## **MARQUETTE CITY PLANNING COMMISSION** **Tuesday, May 5, 2026, at 6:00 p.m.** **Room 103, Municipal Service Center at 1100 Wright Street**

**TO:** Planning Commission  
**FROM:** Andrea Landers, Zoning Official  
**DATE:** April 23, 2026  
**SUBJECT:** 04-SPR-05-26 – 1101 W US 41 (PIN: 0514233)

**Project/Application:** Final Site Plan Review for the construction of a new commercial building, new parking lot, dumpster enclosure, landscaping, and site improvements.

Plan Title: Marquette GMC Site Development

SITE PLAN

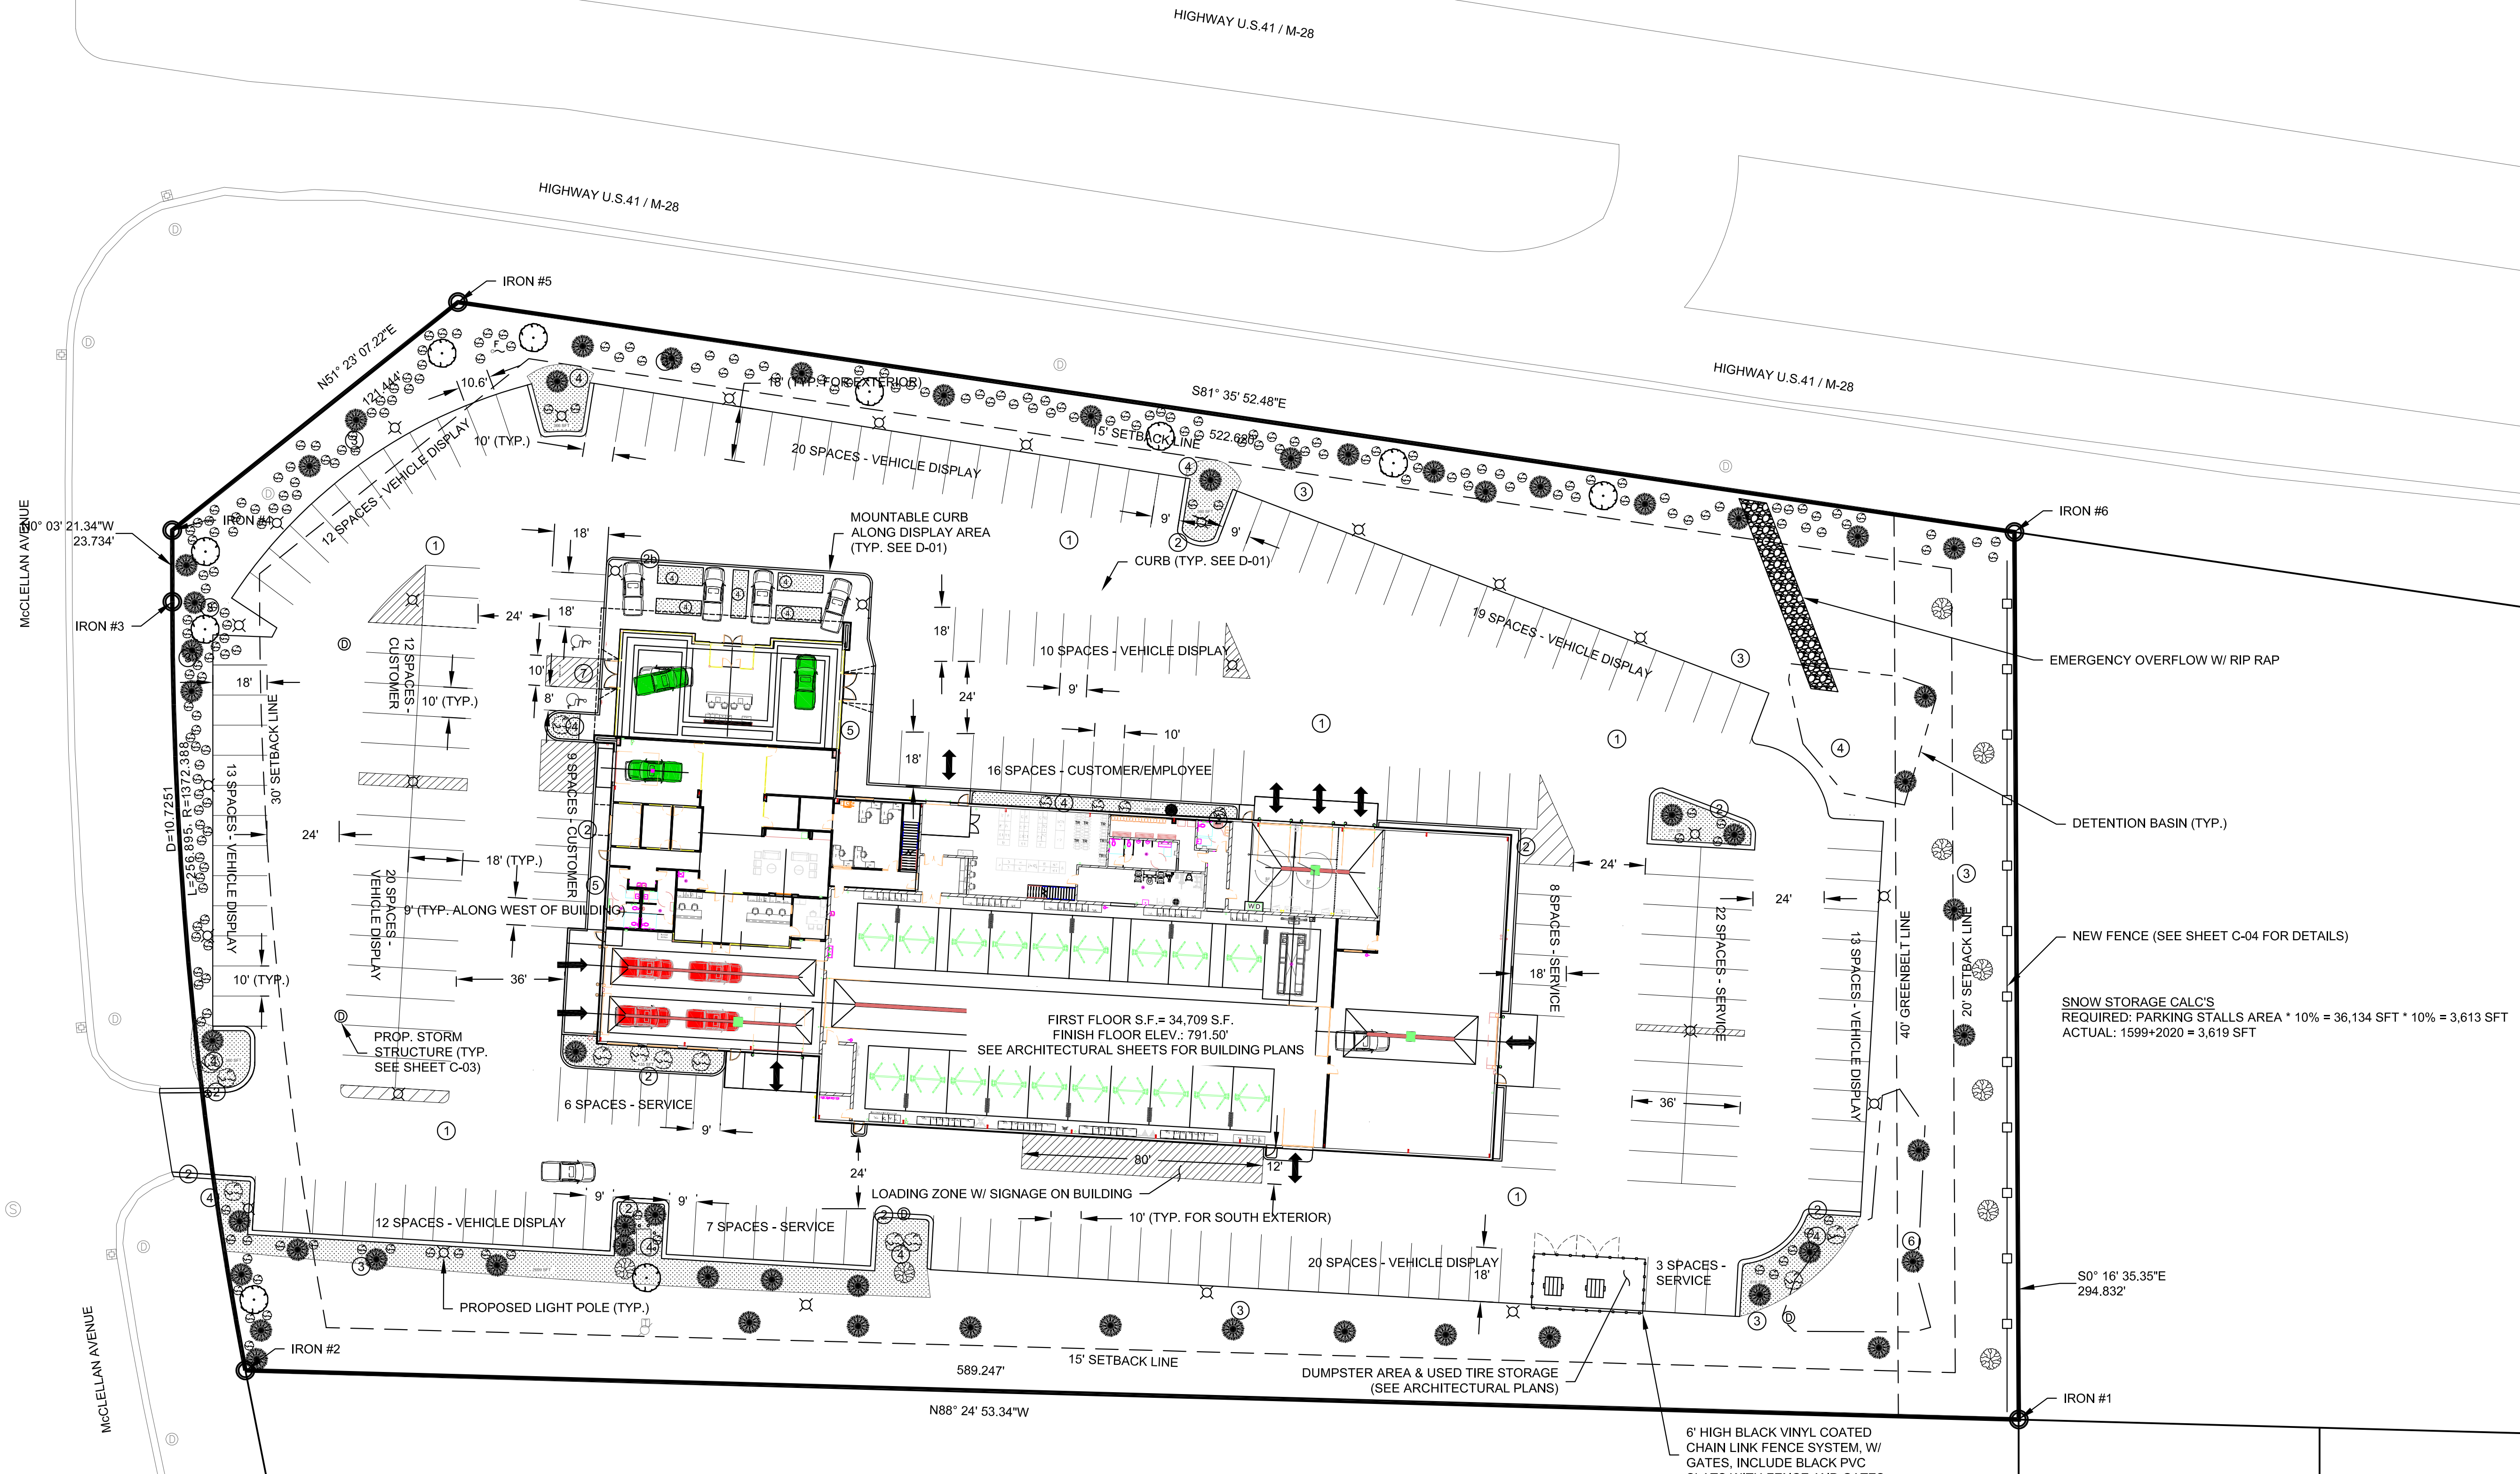
**The proposal exceeds the minimum parking space requirements of approximately 15 spaces for the use calculations. With 139 spaces for the vehicle display. Please see their response to zoning General Comments and Sheet C-01.**

**Per the site plan application sheet C-01, they will store their trash and used tires inside a proposed dumpster area enclosure that will consist of a 6-ft high black vinyl coated chain link fence and gates with pvc slats.**

DWG. NO.  
C-04

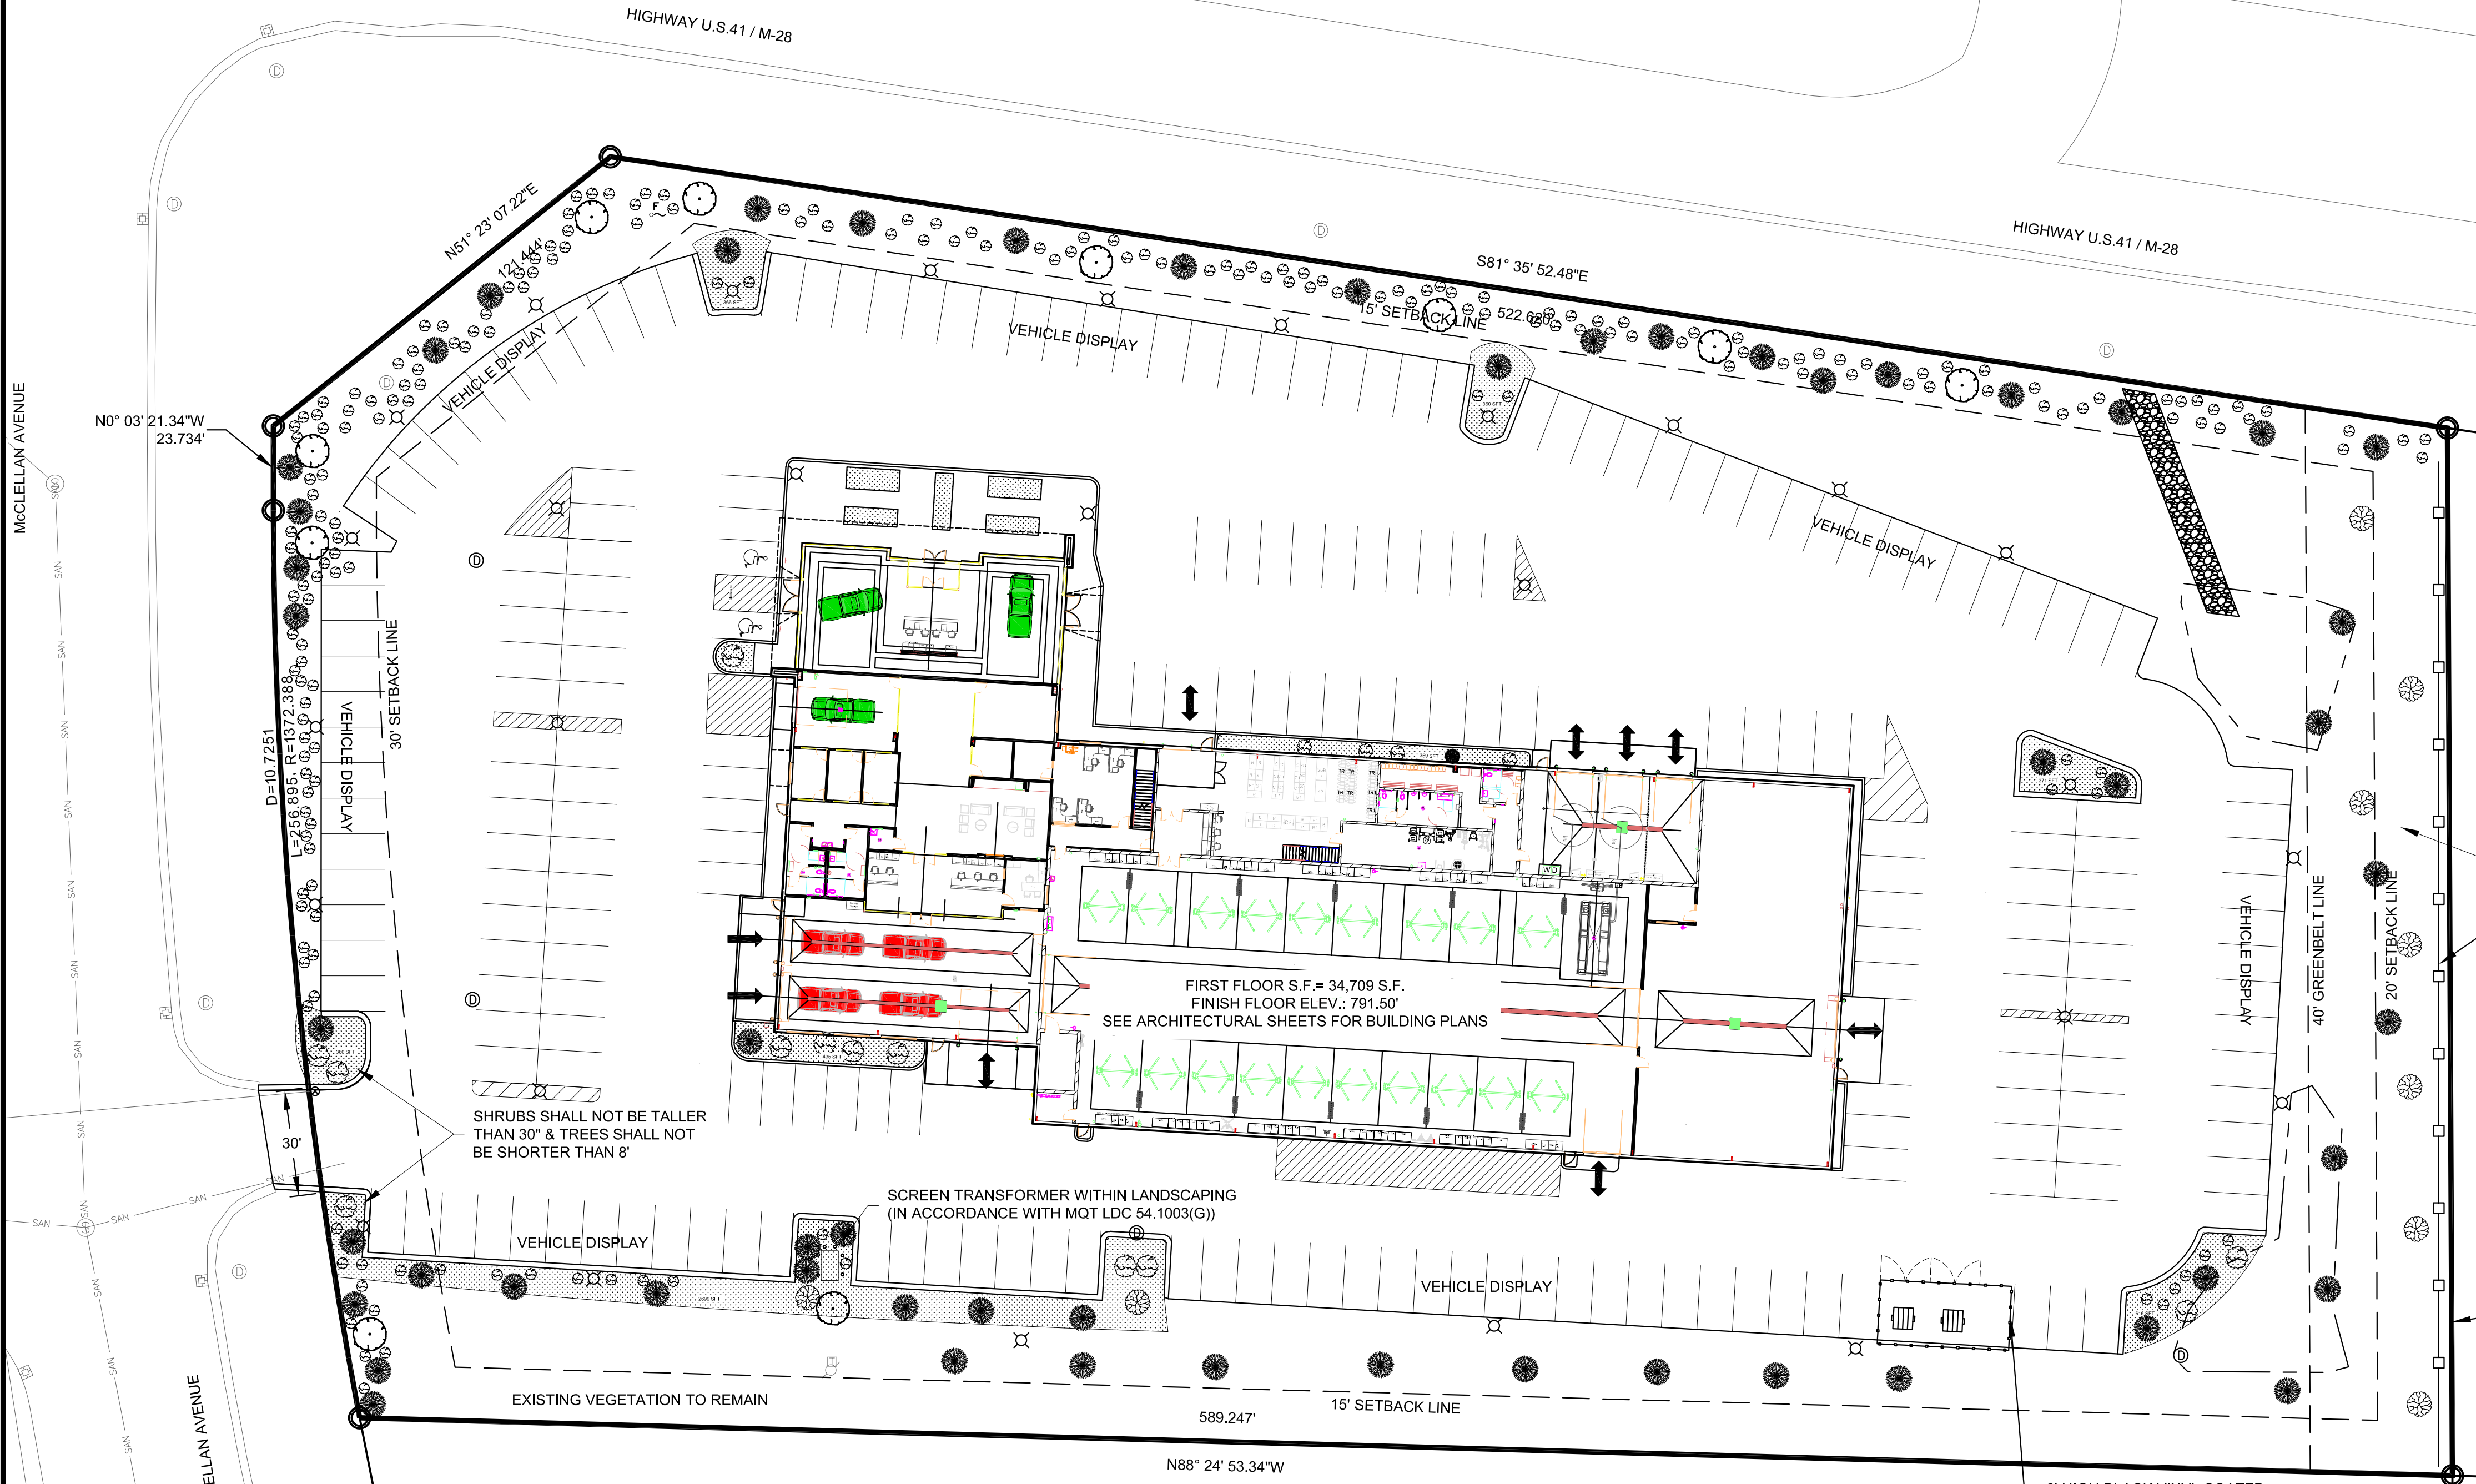
**Landscaping details are provided on Sheet C-04. Please see Zoning comments and applicants' responses regarding the proposed landscaping for Sheet C-04.**

2. Section 54.1003, Figure 63 **Standards for Plant Materials – Recommended Plant Types and Sizes** has been amended. Please revise your chart on this page to reflect the updated Figure 63. **Landscaping will be revised to meet the new requirements.**
